PLANNING COMMISSION MEETING

Project Name: Sunset Cove
 Description: Preliminary site plan & special land use approvals
 Date on Agenda this packet pertains to: March 2nd, 2023

RE: Sunset Cove Condominiums- Preliminary Site Plan Review – 2nd Review

RE: Sunset Cove
Preliminary Site Plan and Special Land Use – Review #2

SHEET 2

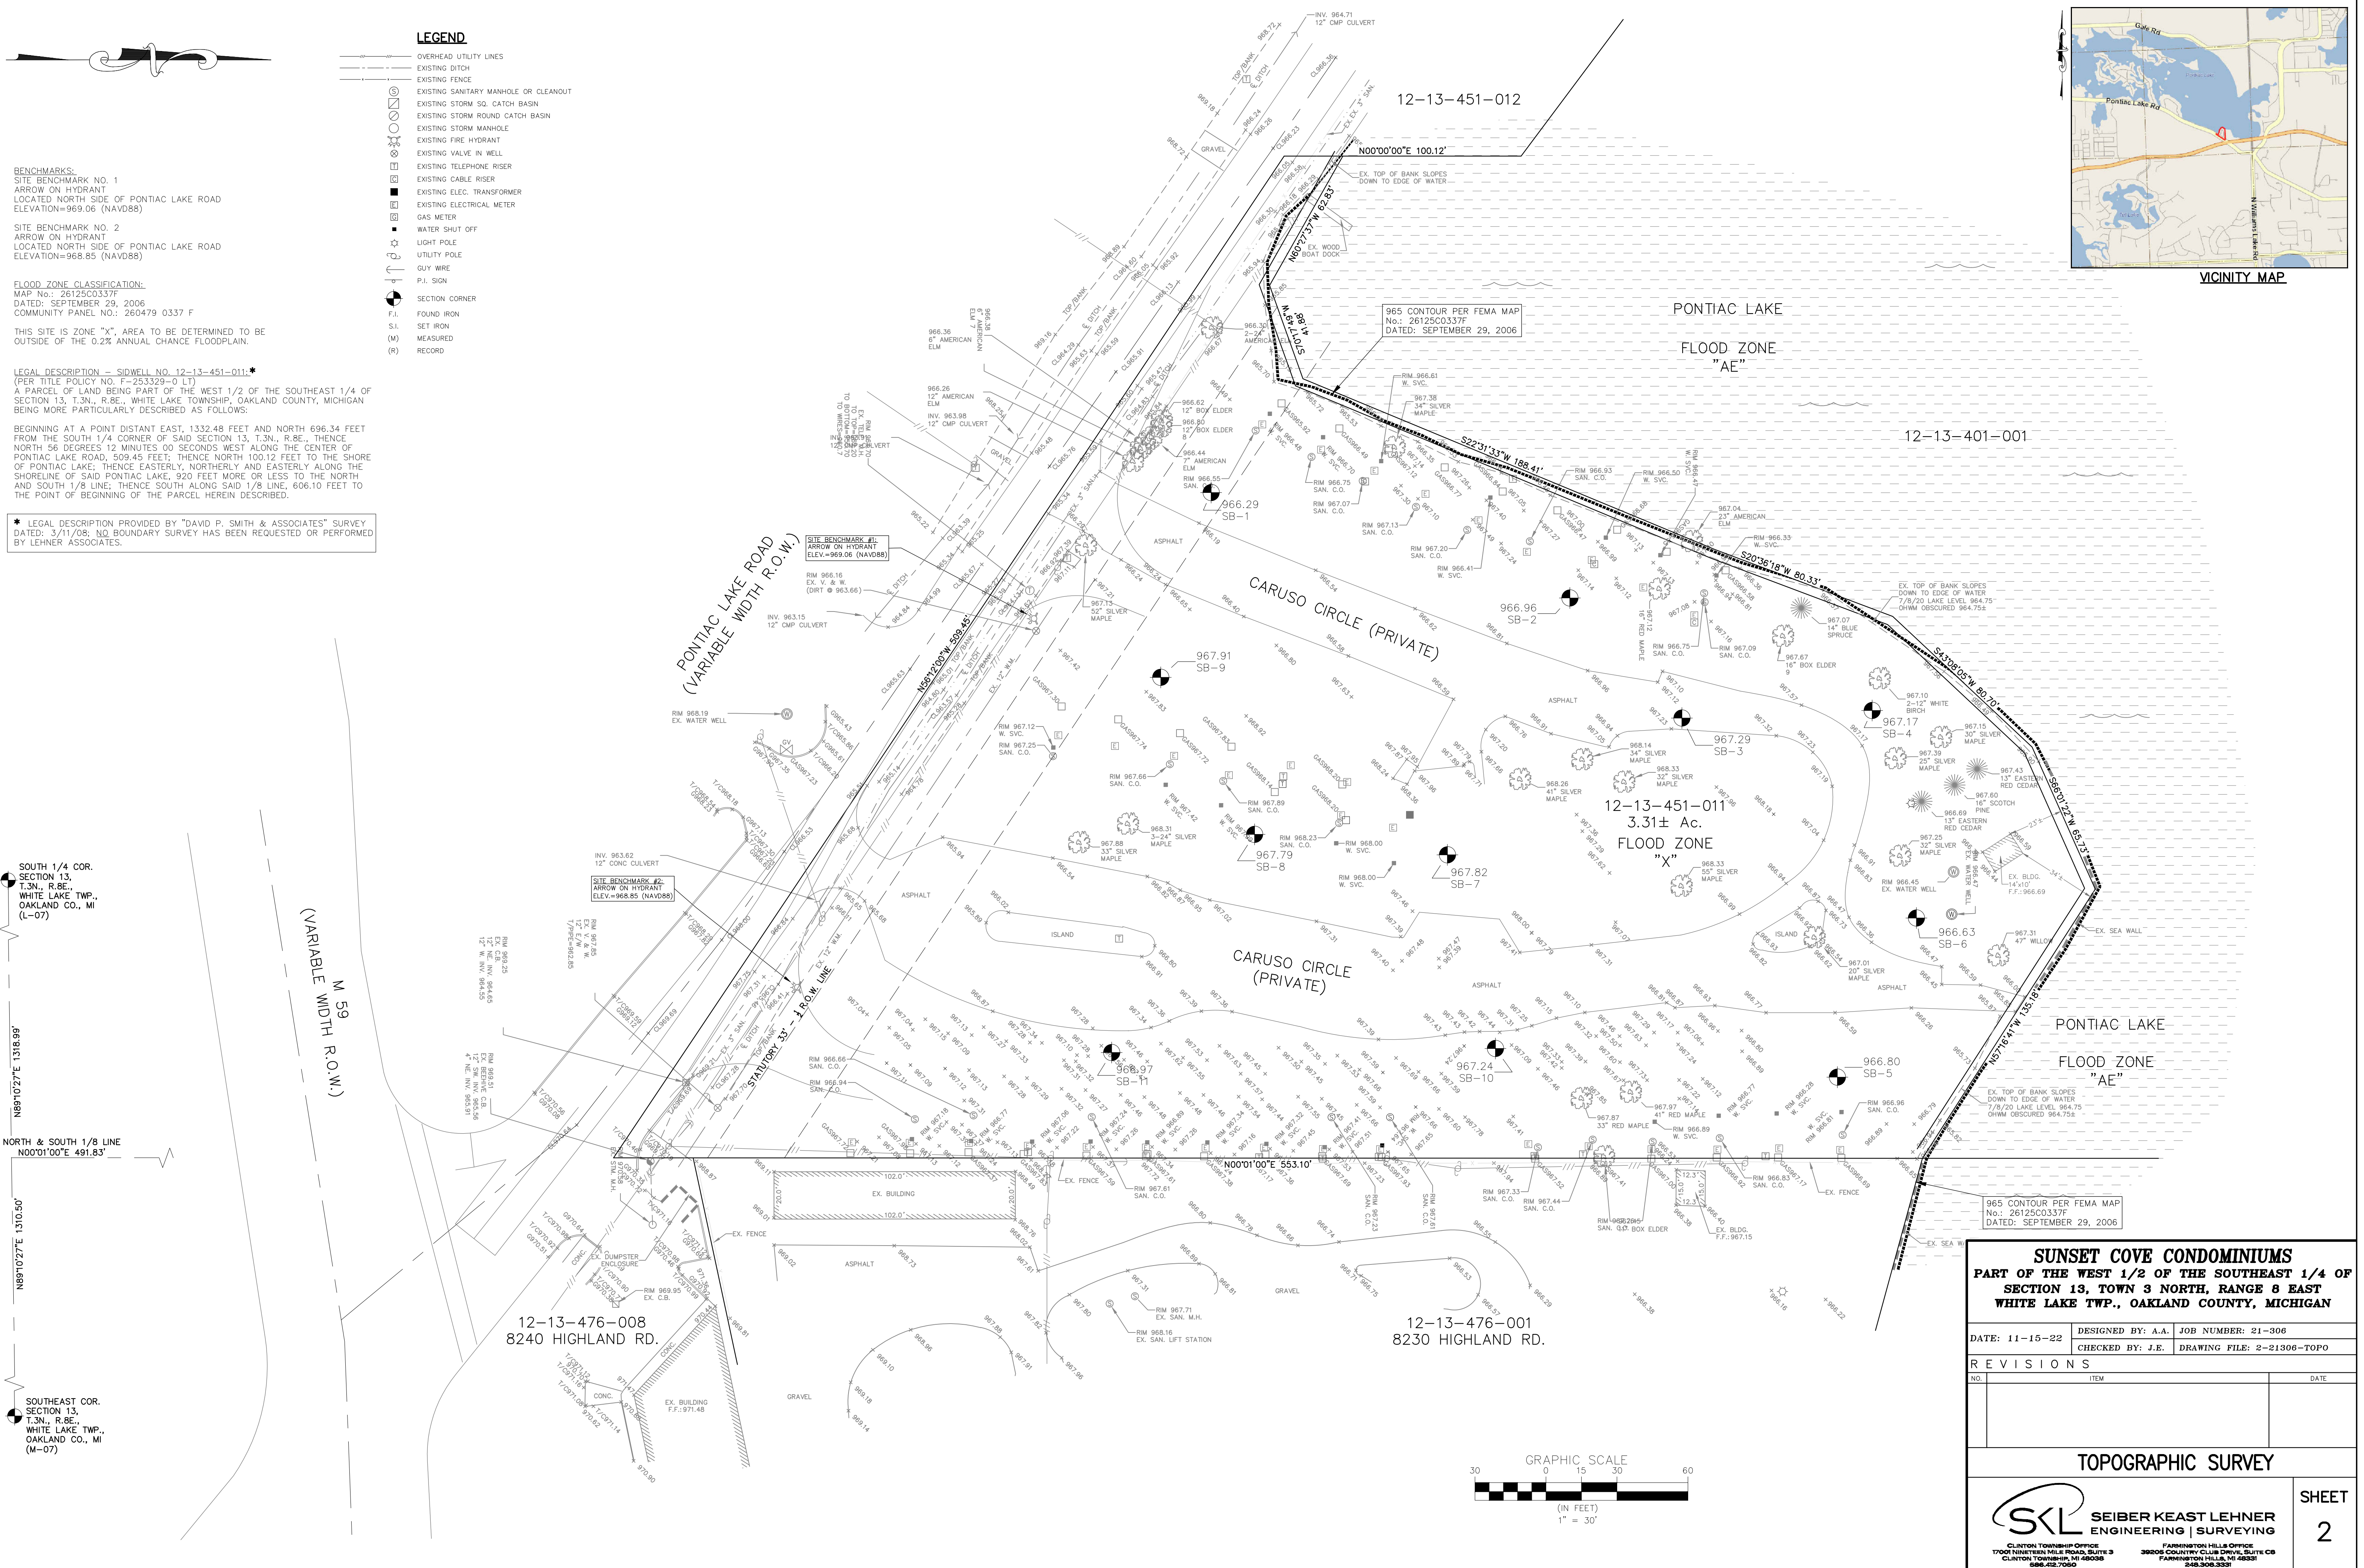
- a) *The site benchmarks shown will be invalid once construction starts as the two hydrants being used as benchmarks are proposed to be relocated. Provide two additional permanent benchmarks for the site (on NAVD88 datum).* **Comment addressed at this level of review. The designer has noted that additional site benchmarks will be established after PSP approval. We note that new benchmarks will be required to be shown on the FSP/FEP.**

- b) *The legal description provided does not appear to correspond with the metes and bounds shown in plan view on the Topographic Survey Sheet 2. Please revise as necessary.* **Comment addressed at this level of review. The designer has indicated that a boundary survey and legal description will be prepared after the PSP approval. This item will be required to be addressed on the FSP/FEP.**

SHEET 3

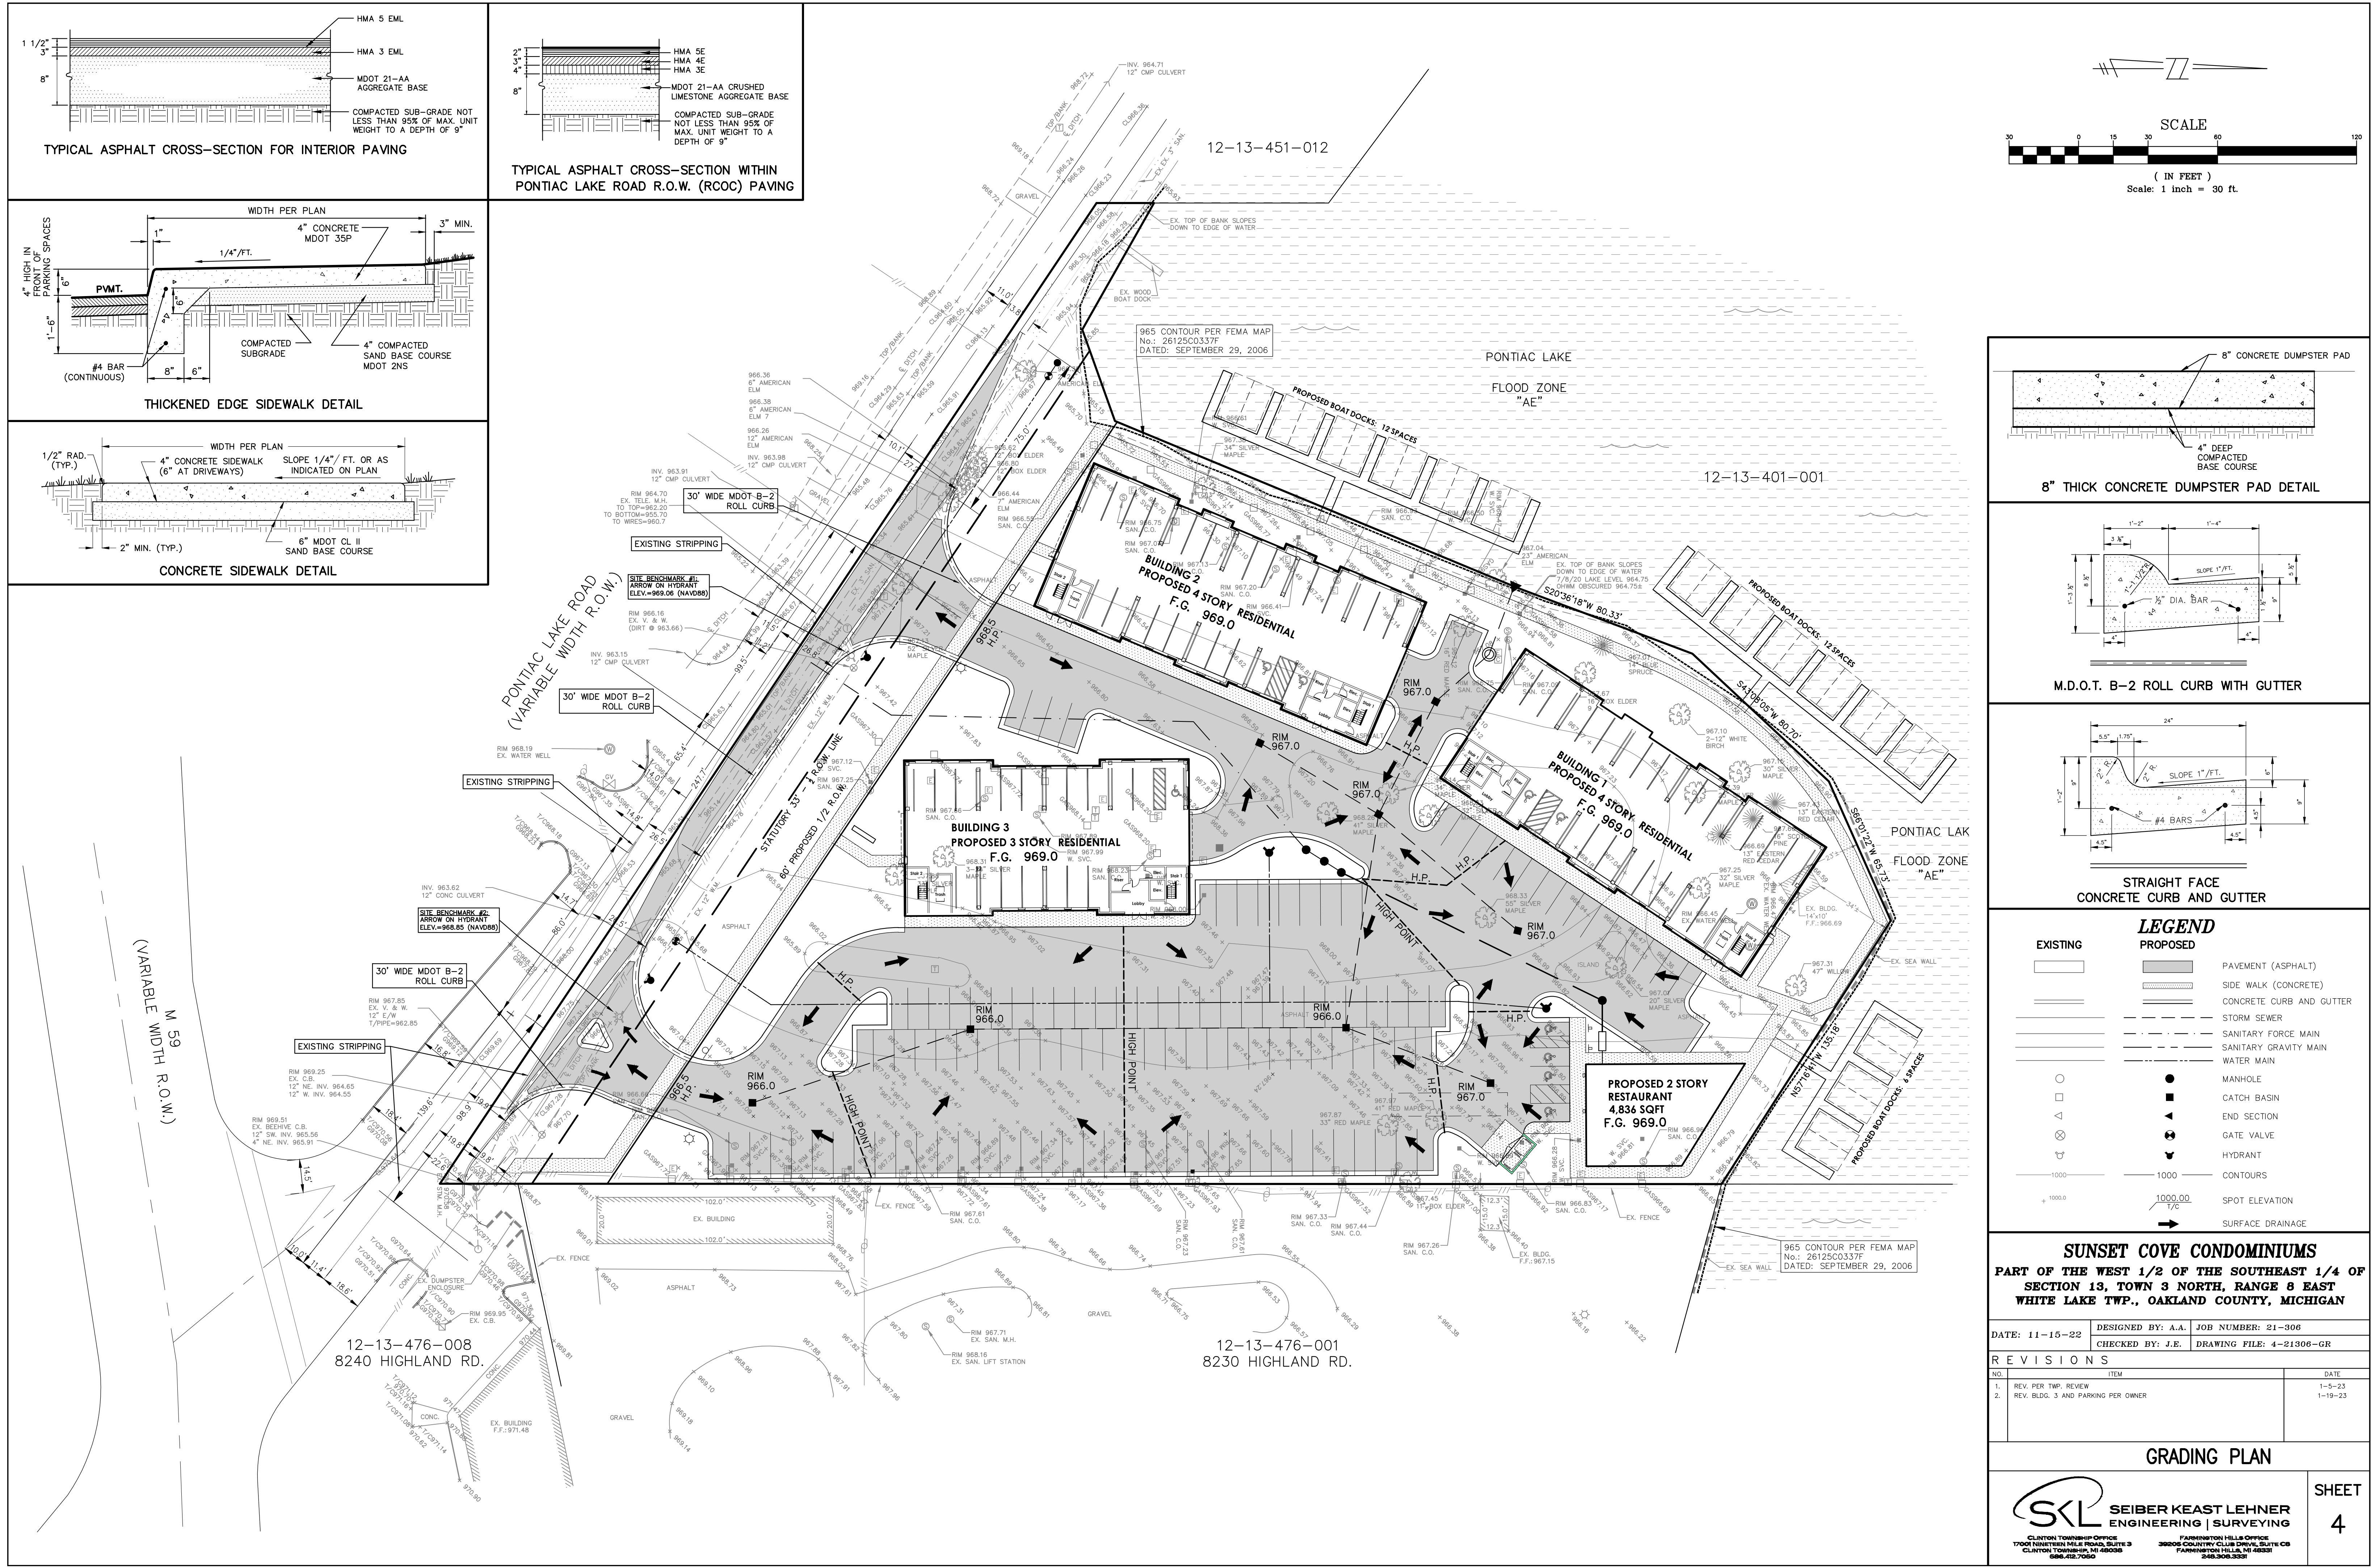
A trash collection plan shall be provided for the residential portion of the project. (Comment partially addressed. Trash rooms are now shown on the ground floor of the residential buildings on Sheets 3, A.100, and A.101. The Developer shall clarify if the intent is for a trash collection company to drive a trash truck through the site, stop at each building, enter the garages to collect trash from the trash rooms, and take the trash to the trash truck).

The zoning ordinance requires each individual parking space be delineated by dual stripes, two feet apart centered on the dividing lines and painted white. The site plan shall be revised to indicate the required striping. (Comment outstanding. The site plan shall be revised to show the required box pattern). Additionally, a parking stall striping detail shall be provided for the barrier-free space and access aisle as well as the standard space. A “Van Accessible” sign detail for the barrier-free parking shall also be provided. (Comments addressed. The aforementioned details have been added to Sheet 3).

The existing wood boat dock at the west property line shall be removed (note on site plan). (Comment addressed. A note indicating removal has been added to Sheet 3).
